GCC Rio Grande, Inc. Tijeras Cement Plant & Limestone Quarry:
Quarry 1 PMT Design Regulatory Agency Comments Draft Responses

Figure 1. Slope before Mining (top) and Slope immediately after Mining the Toe of Slope (bottom)

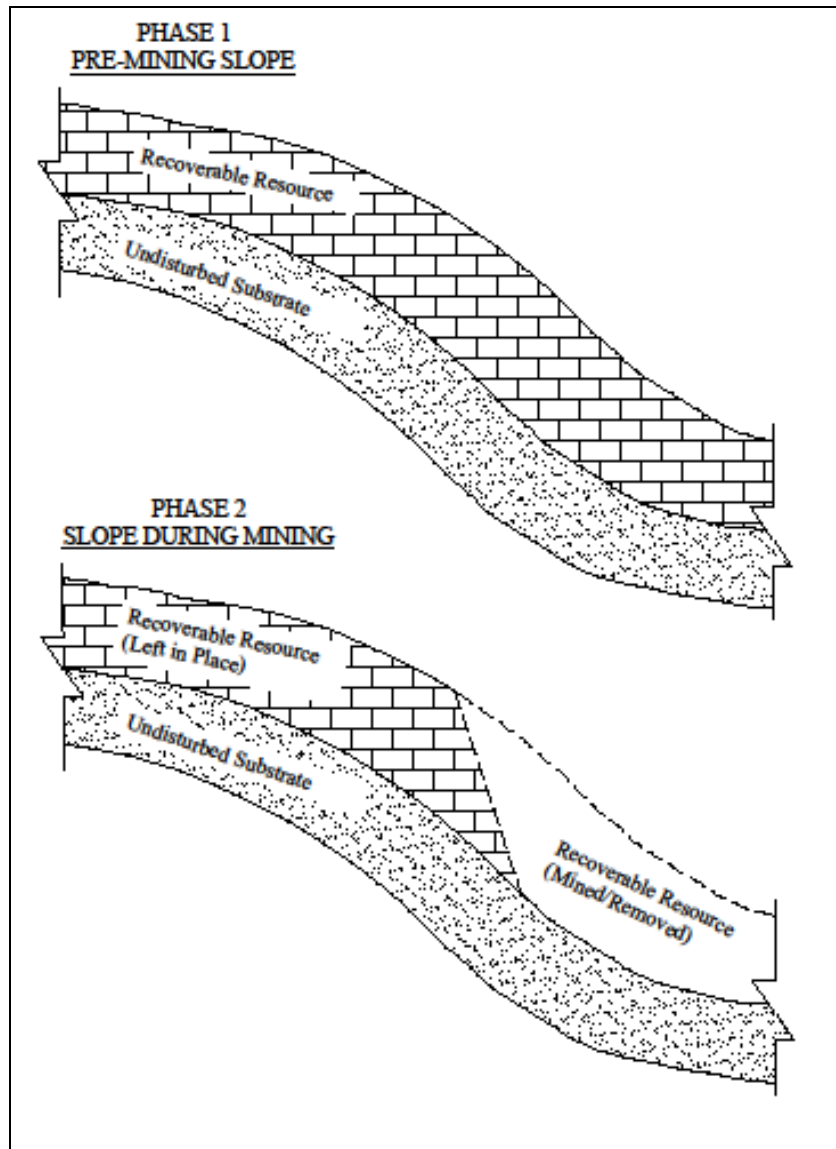
NMED MECS Comment 1: "GCC should elaborate on the method used to remove the slope failure..."

The slope failure occurred due to the mining process. The limestone resource was mined from the bottom of the slope and across it, proceeding uphill (Figure 1). Mining of the lower limestone removed the physical support for the upper portion, and it moved downhill (Figure 2). For safety reasons mining operations ceased in Quarry 1 when the upper limestone member started to move downhill.

Figure 3. Examples of Stable Slopes Over 200 Feet in Length Within Reclaimed Areas

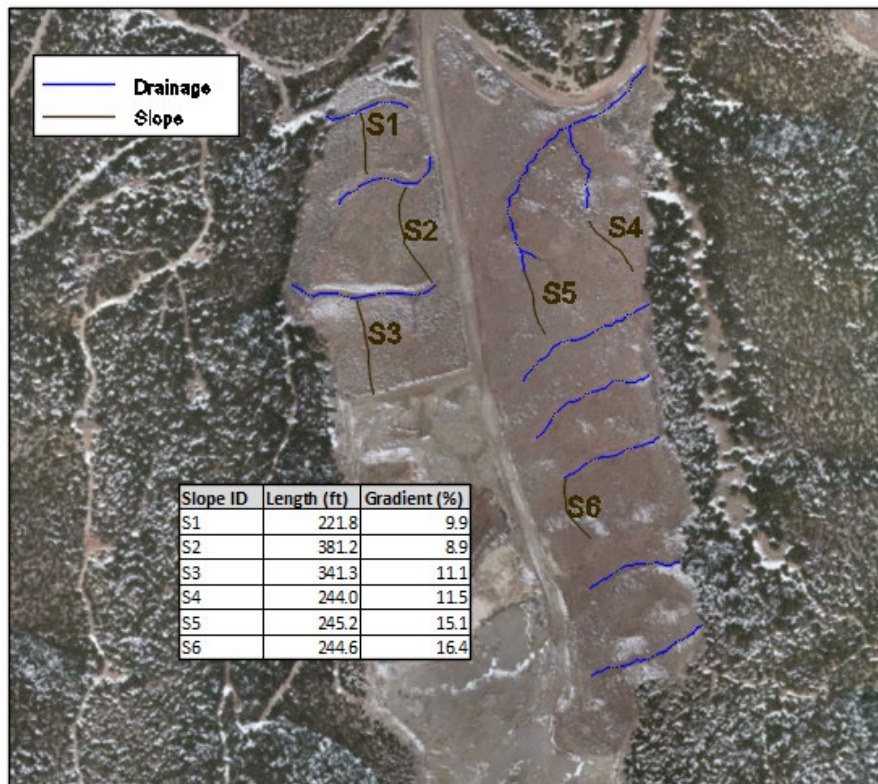
NMED MECS Comment 3: “NMED recommends limiting slope lengths on reclaimed slopes to 200 feet in length.”

We agree with the NMED that slope lengths should be limited to 200 ft or less when possible, specifically in steeper gradient areas. The proposed Quarry 1 PMT was specifically designed to minimize slope length, and there is only one small area with a low gradient slope that is over 200 ft long. The Quarry 1 Reclamation Plan, dated February 12, 2020, included a table of slope length - gradient ratios that result in RUSLE erosion rates comparable to background conditions. RUSLE calculations were carried down to a 15% gradient that yielded a maximum slope length of 273 ft. All other slopes in the design are shorter than 200-ft. The one longer slope is about 250-ft long at a 13% gradient which is stable based on RUSLE evaluation. Furthermore, there are examples of stable slopes longer than 200-ft at gradients of 16.4% or less within reclaimed areas at Tijeras Mine that support the post-mining topographic design in the Quarry 1 Reclamation Plan (Figure 3).

Figure 4. Undisturbed (Background) Drainage Density near Quarry 1

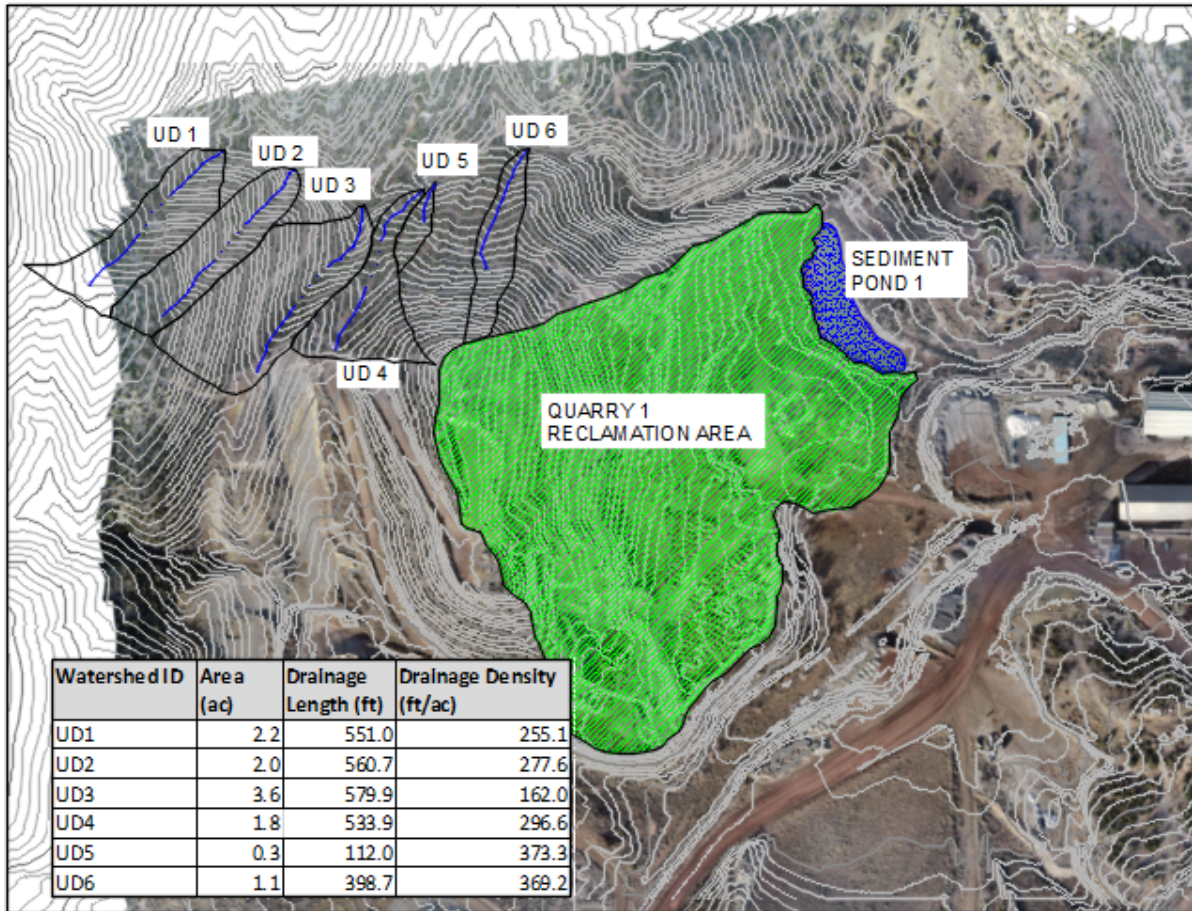
NMED SWQB Comment 1: “To achieve short slope lengths and minimize surface erosion, the PMT requires a drainage density of 451 linear feet per acre. SWQB recommends that this drainage density be compared to the undisturbed drainage density of the surrounding area and that the reclamation plan discuss the potential impacts that may be associated with altering the drainage density.”

Drainage density was measured at six undisturbed (background) watersheds near Quarry 1. The six watersheds range in size from 0.3 to 3.6 acres with drainage densities ranging from 162 ft/ac to 373 ft/ac (Figure 4). The proposed drainage density is about 20% higher than the largest background drainage density.
